ABILENE RESTORATION  
MINISTRIES, INC.  
2018 BEECH STREET

10-3-2025  
ADDENDUM A  
10-26-2025

ABILENE RESTORATION  
MINISTRIES, INC.  
ABILENE, TEXAS

SECOND FLOOR PLAN - PLUMBING

WATER HEATER "WH1" (3-UNIT) SCHEMATIC

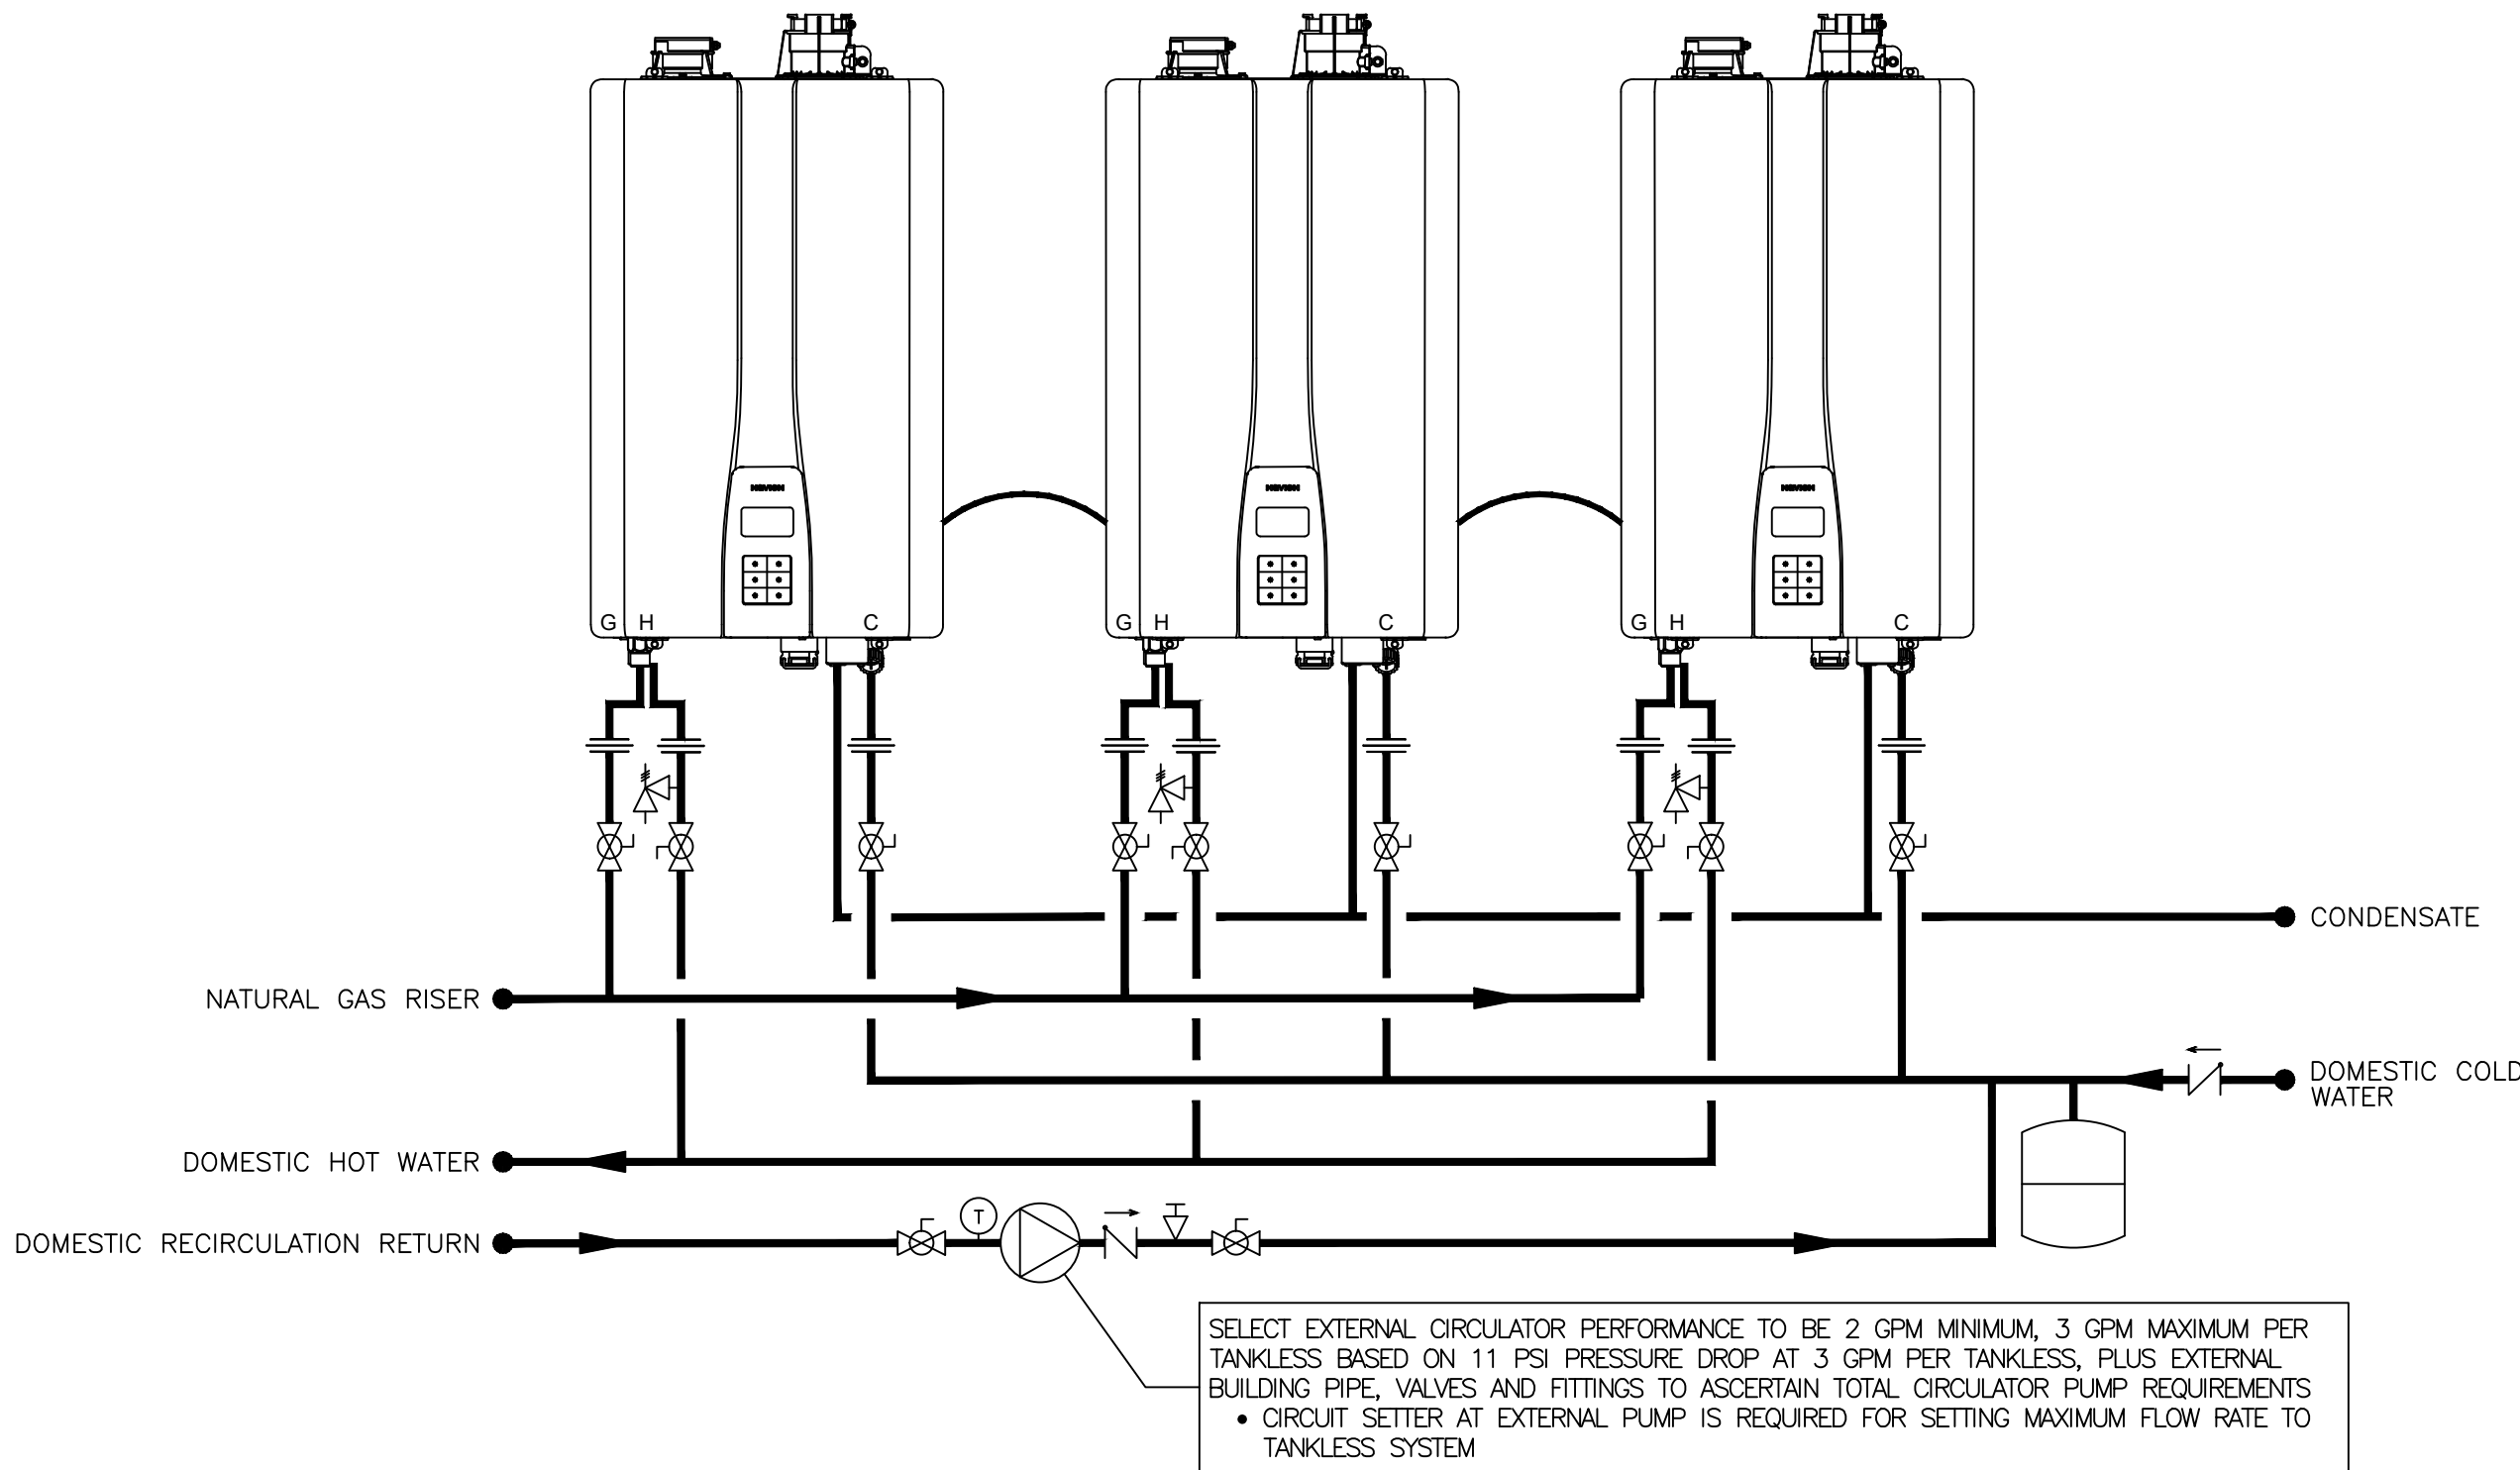
CHANGE WATER HEATERS FROM ELECTRIC TANK TYPE TO GAS FIRED, INSTANTANEOUS.

2) WATER HEATER SYSTEM SHALL BE INSTALLED PER MANUFACTURERS RECOMMENDATIONS AND IN ACCORDANCE WITH ALL APPLICABLE CODES  
3) INDOOR HEATERS SHALL HAVE 2" DIAMETER SCHEDULE 40 CPVC VENT & INTAKE CONNECTED TO COMMON 4" EXHAUST VENT AND COMMON 4" INTAKE PER MANUFACTURER'S REQUIREMENTS.

4) PROVIDE 2" SCHEDULE 40 STEEL GAS HEADER AND 3-FOOT LONG 3/4" CCST FLEXIBLE GAS LINE TO EACH HEATER.  
5) PROVIDE 2" COPPER HOT AND COLD WATER HEADERS WITH 2-FOOT LONG 3/4" FLEXIBLE STAINLESS STEEL WATER LINES TO EACH HEATER.

FIRST FLOOR PLAN - POWER

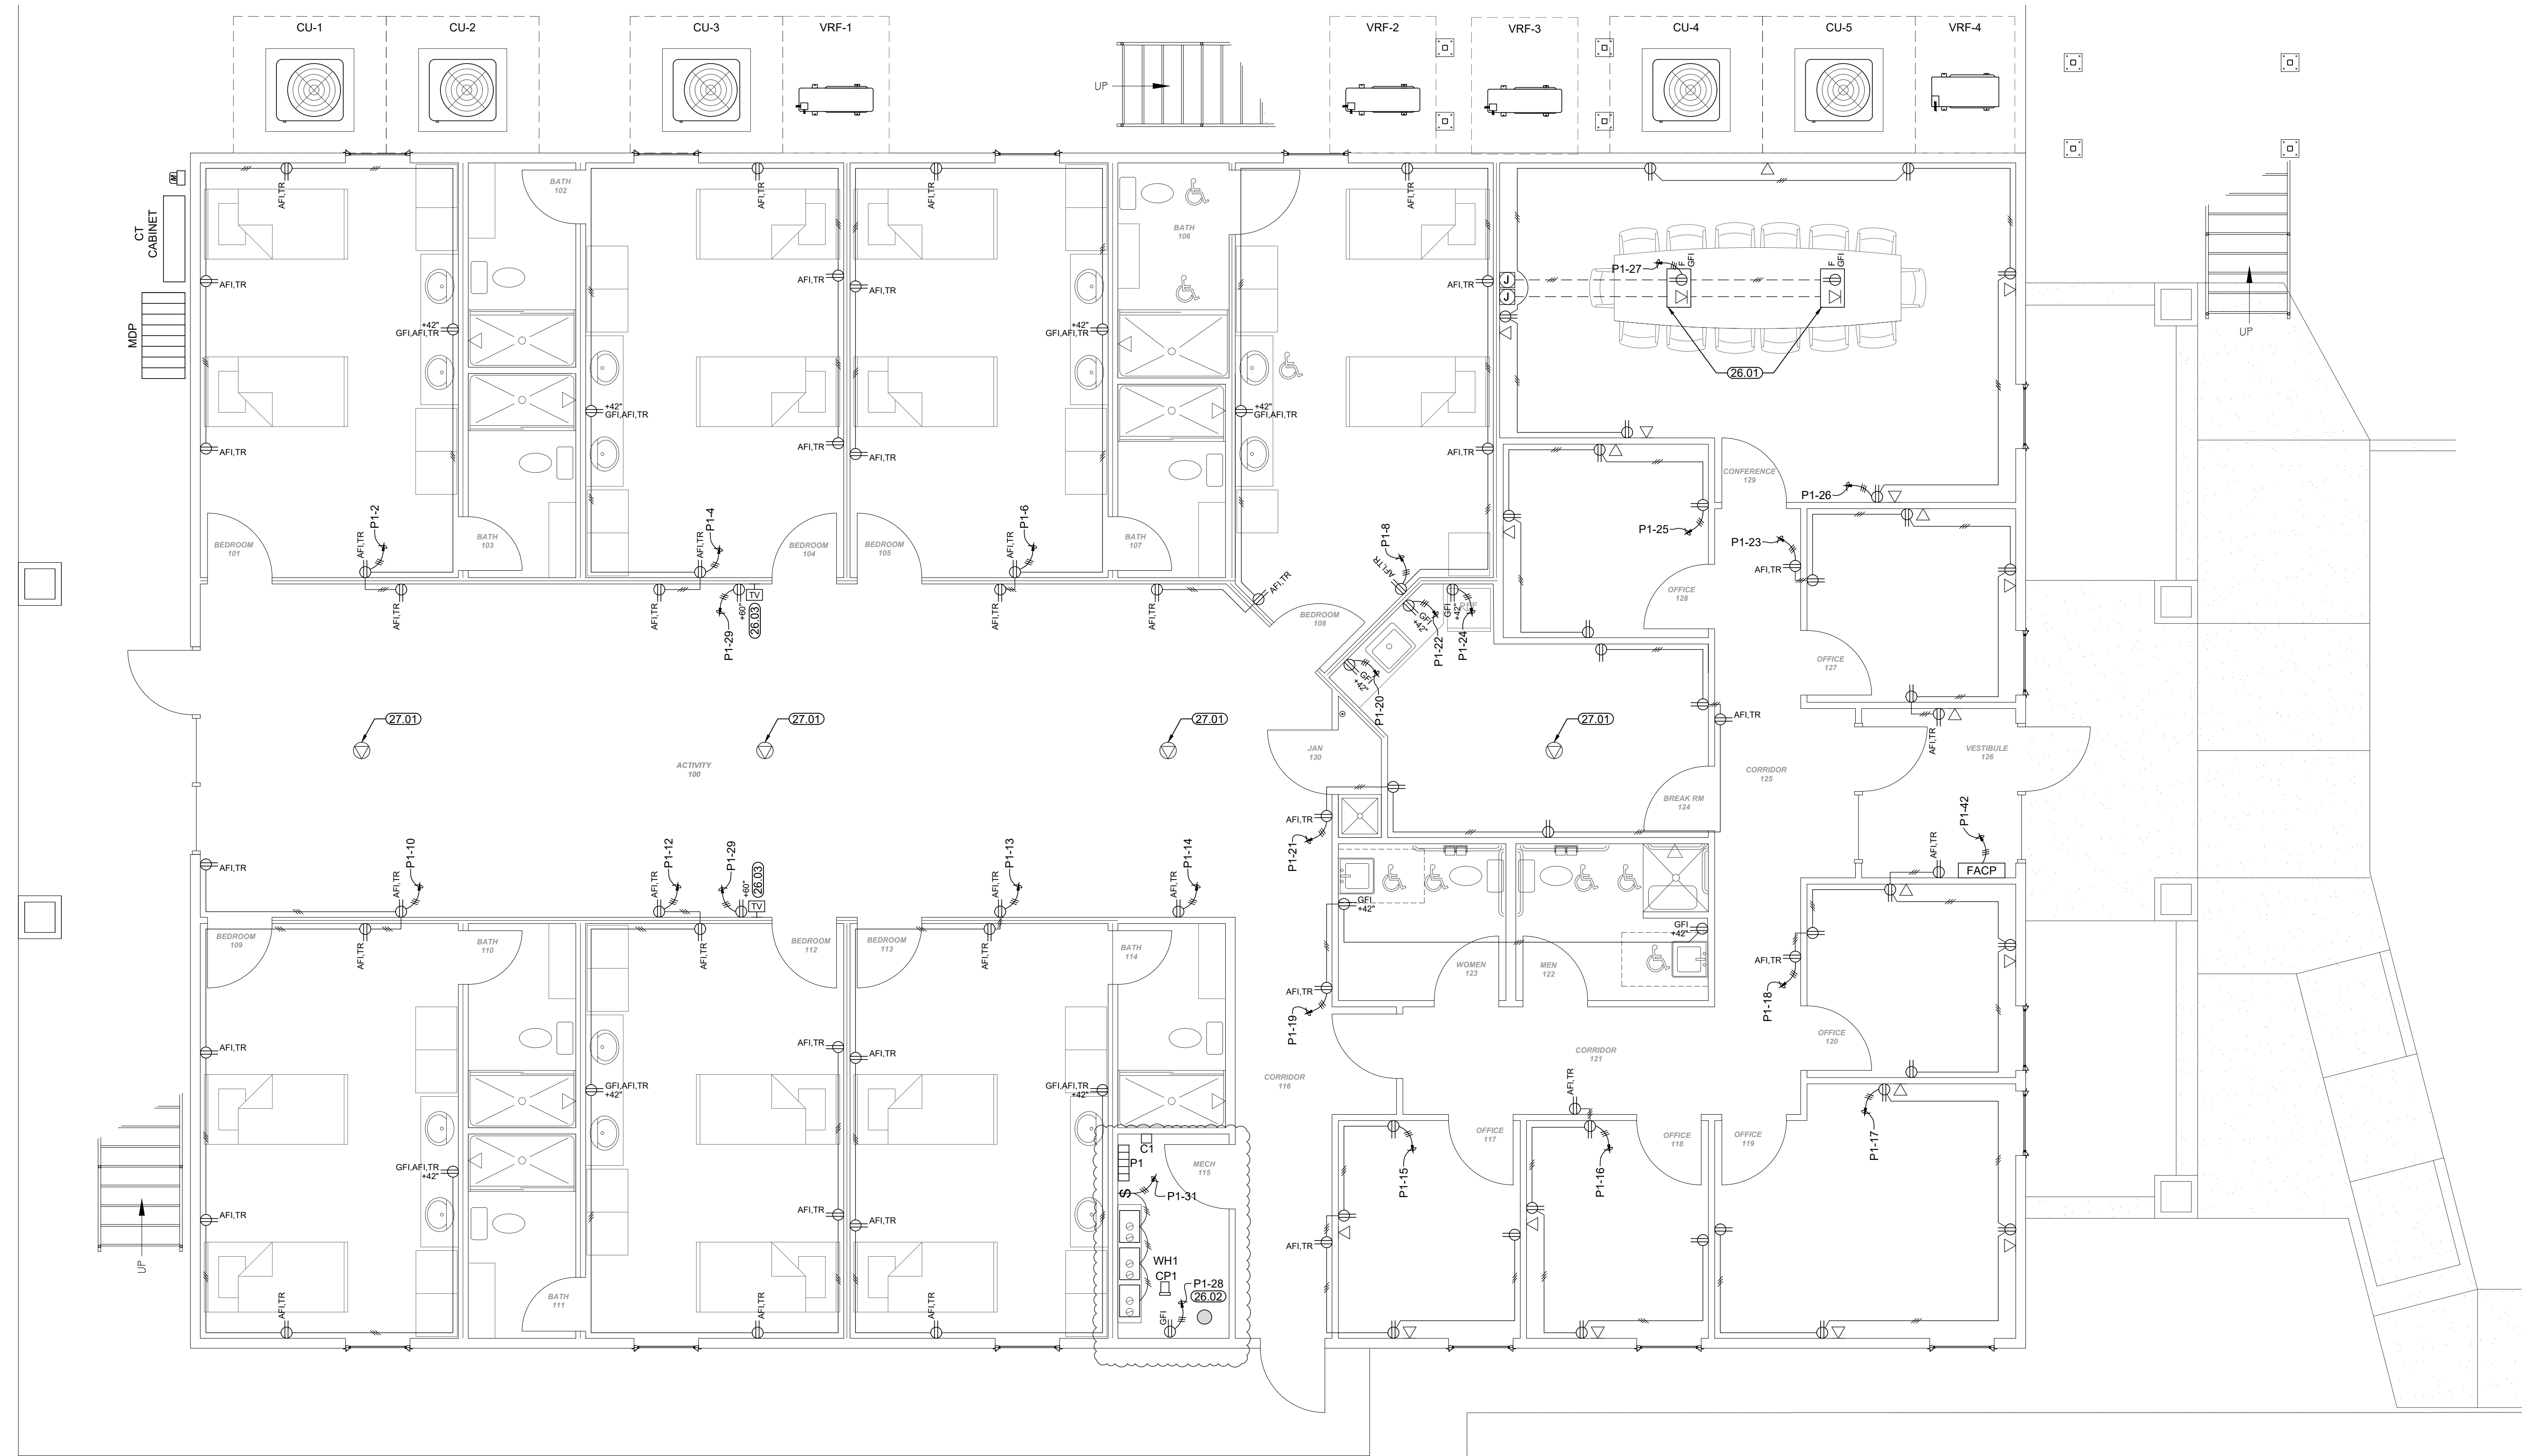
**ADDENDUM ONE:**  
CHANGE WATER HEATERS FROM ELECTRIC TO GAS FIRED, INSTANTANEOUS.

571-14-20.DWG  
**14.20**  
Copyright: 2025

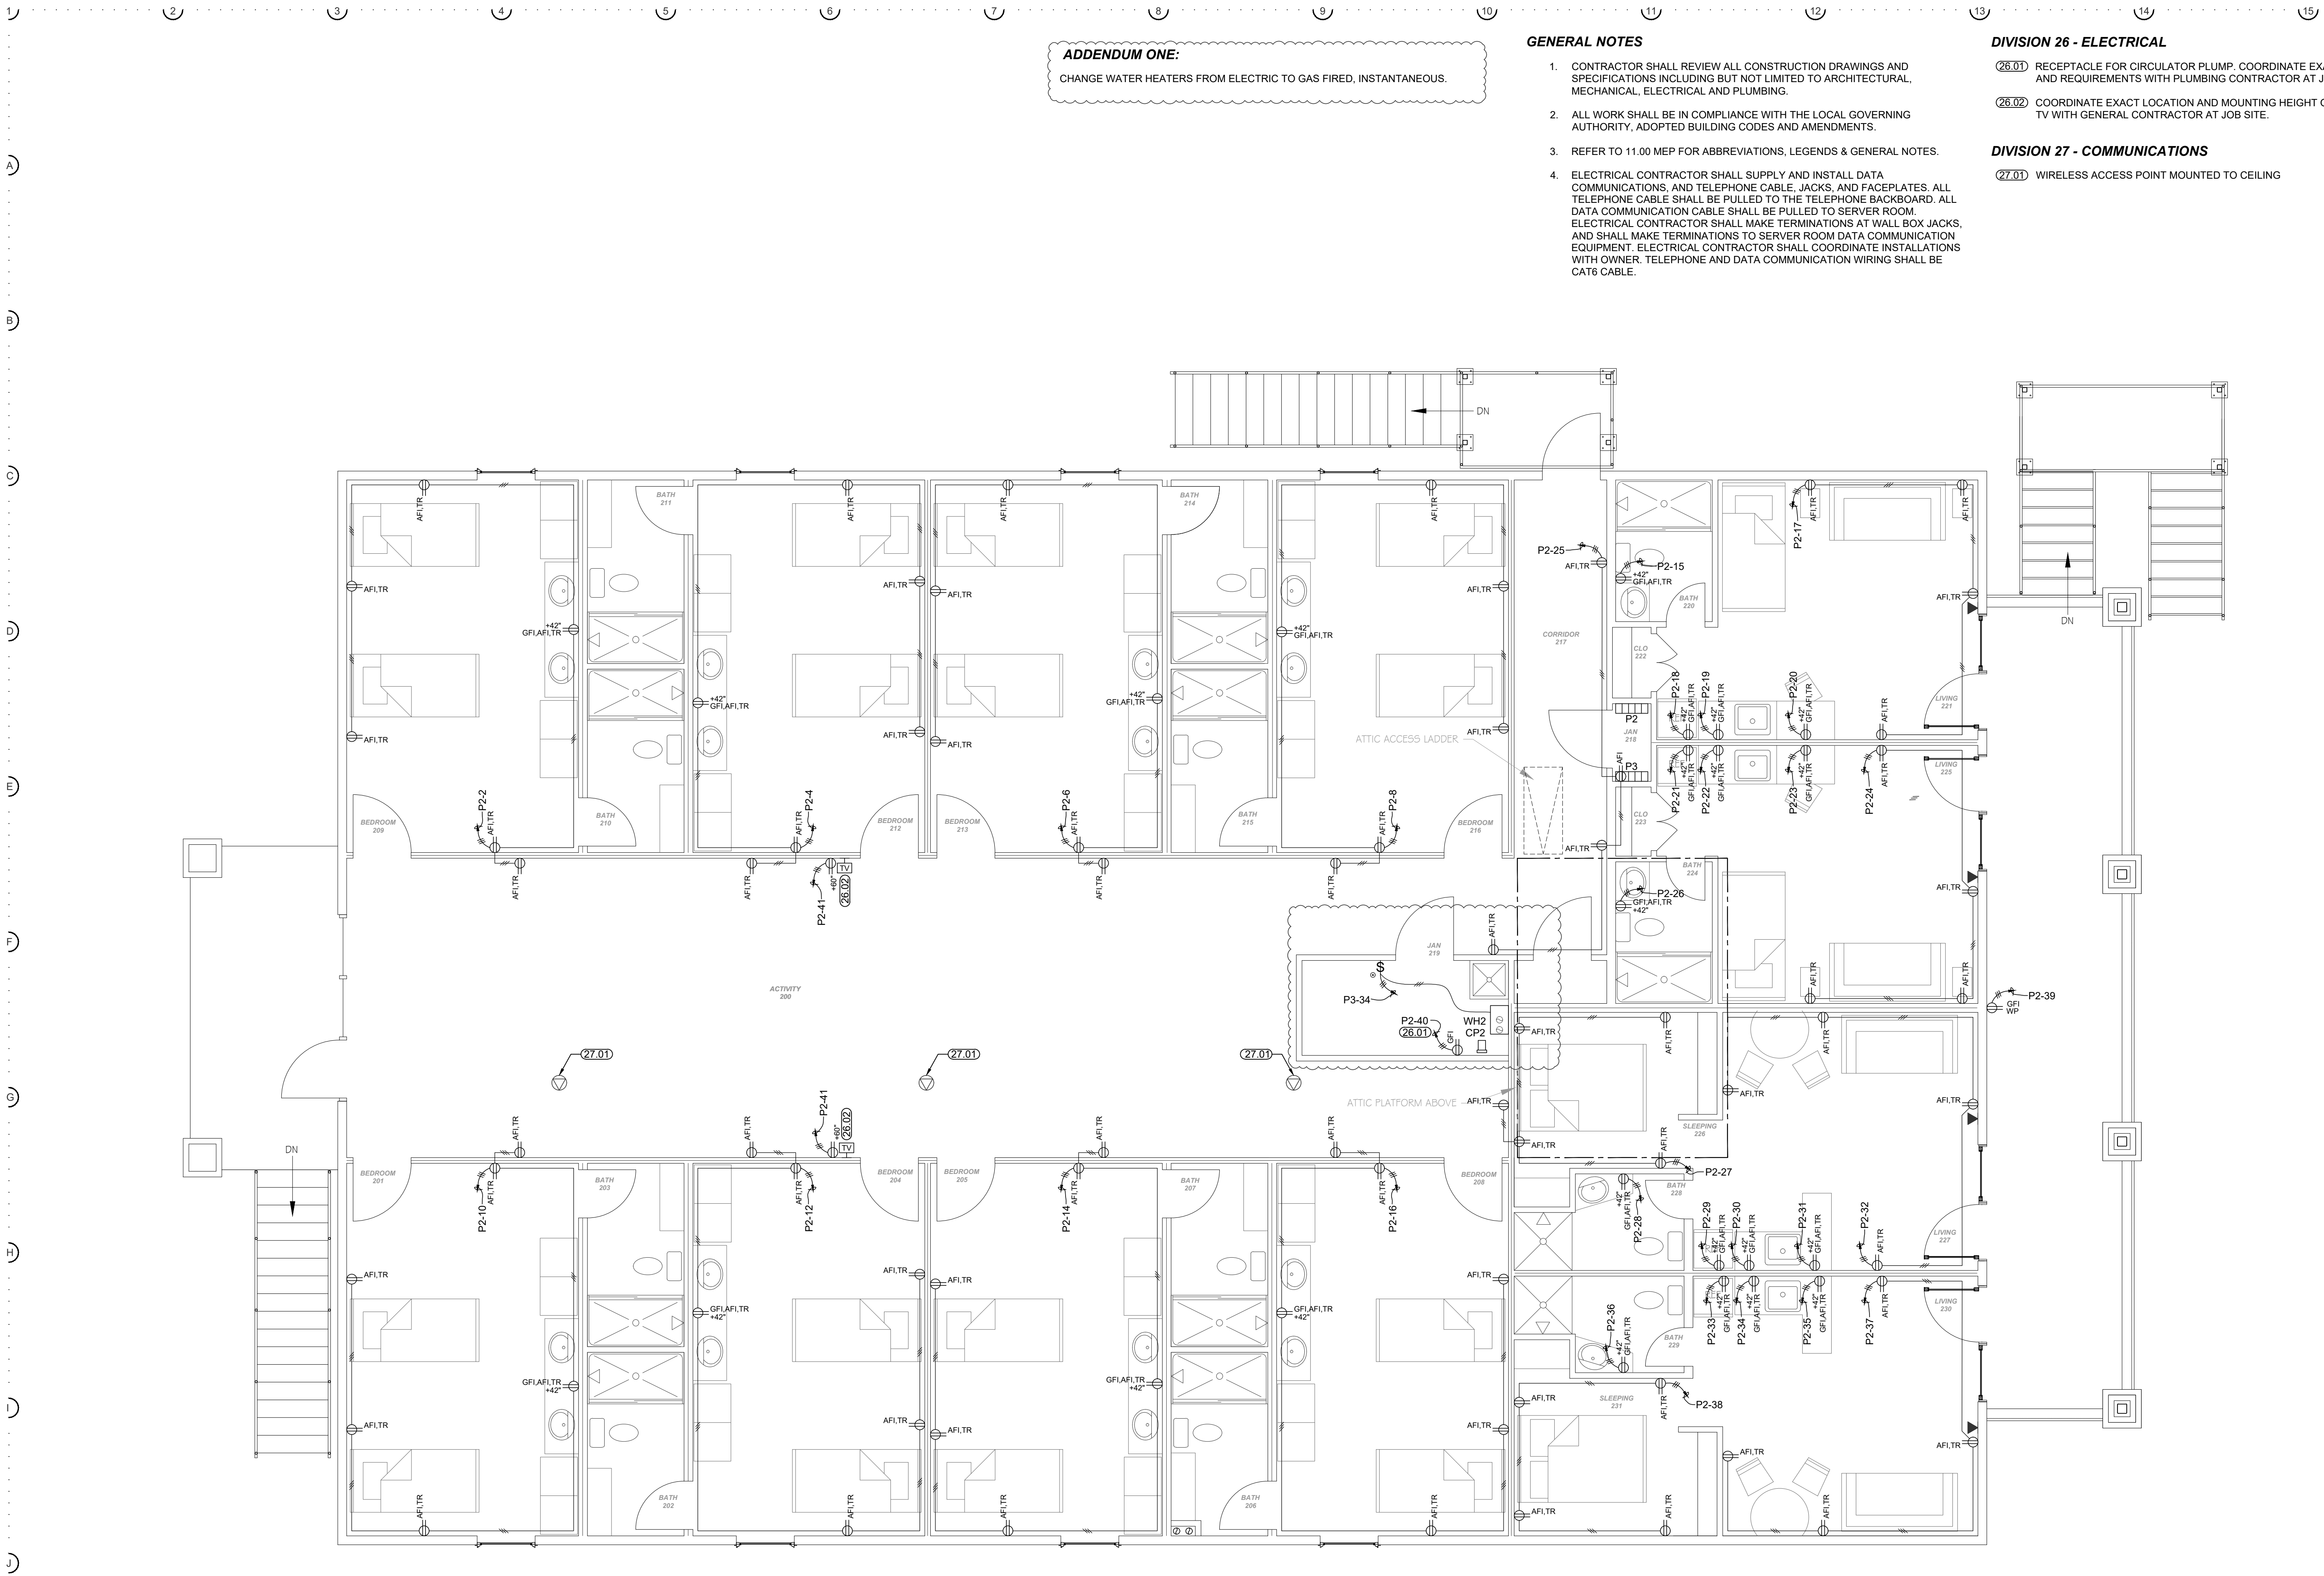
**ADDENDUM ONE:**  
CHANGE WATER HEATERS FROM ELECTRIC TO GAS FIRED, INSTANTANEOUS.

- (26.01) RECEPTACLE FOR CIRCULATOR PLUMP. COORDINATE EXACT LOCATION AND REQUIREMENTS WITH PLUMBING CONTRACTOR AT JOBSITE.
- (26.02) COORDINATE EXACT LOCATION AND MOUNTING HEIGHT OF THE OUTLET & TV WITH GENERAL CONTRACTOR AT JOB SITE.
